ASSESSMENT REPORT

Section 75W Modification
Mayfield West Remediation Project

Figure 2: Proposed Site Layout

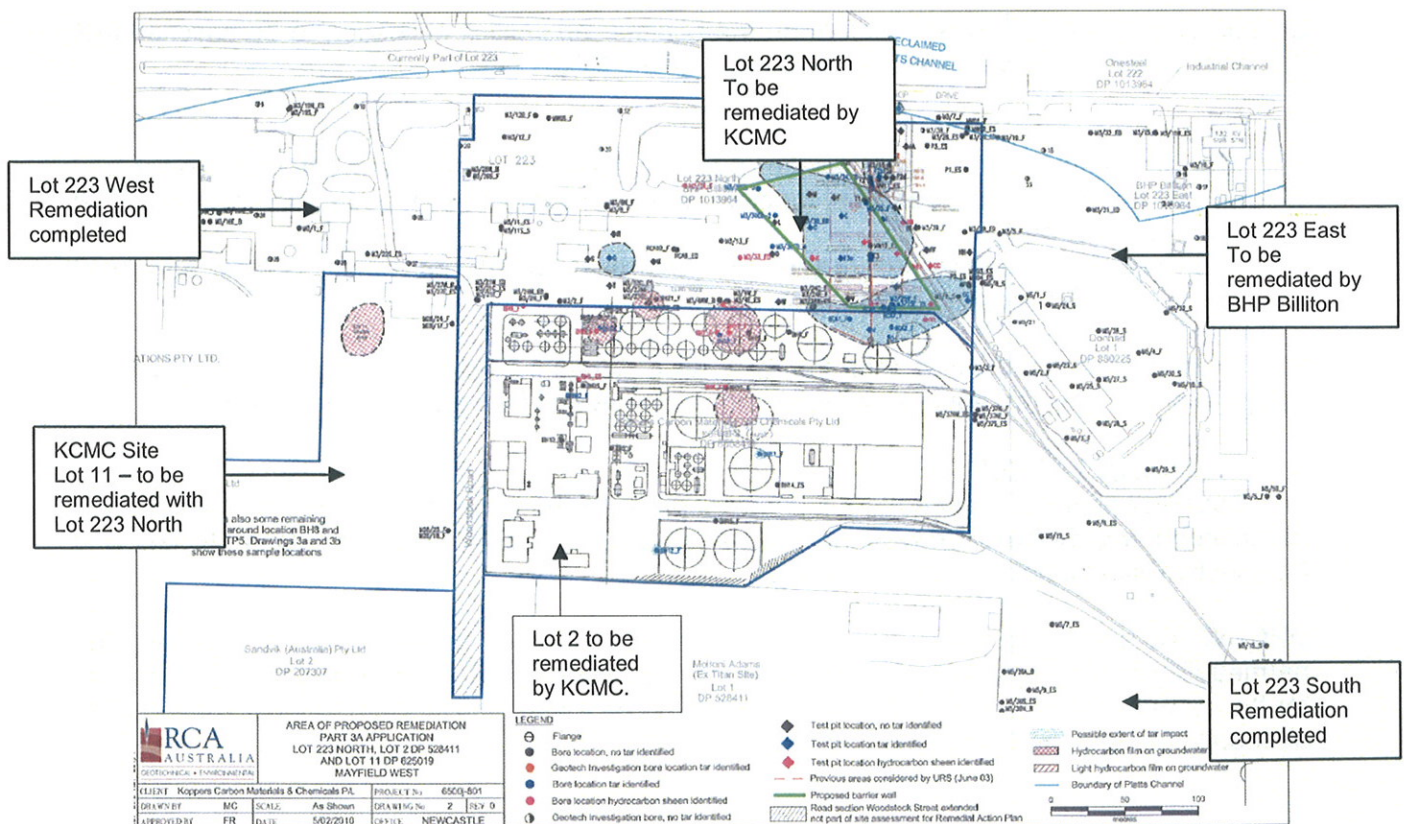
- excavation of fill to bedrock for the installation of a deep, low permeability 4 sided barrier wall containment facility in a portion of Lot 223 North, constructed around an existing area of contaminated soil and groundwater;
- excavation and stockpiling of clean fill from within the barrier wall containment area for use elsewhere onsite;
- excavation of soil/fill from within areas of known hydrocarbon contamination, to be backfilled into the barrier wall containment area;
- limited treatment of hydrocarbon contaminated groundwater in Lot 11;

- installation of a final capping layer to prevent groundwater infiltration and human exposure of contaminated fill materials; and
- installation and monitoring of an Attenuation Bore field.
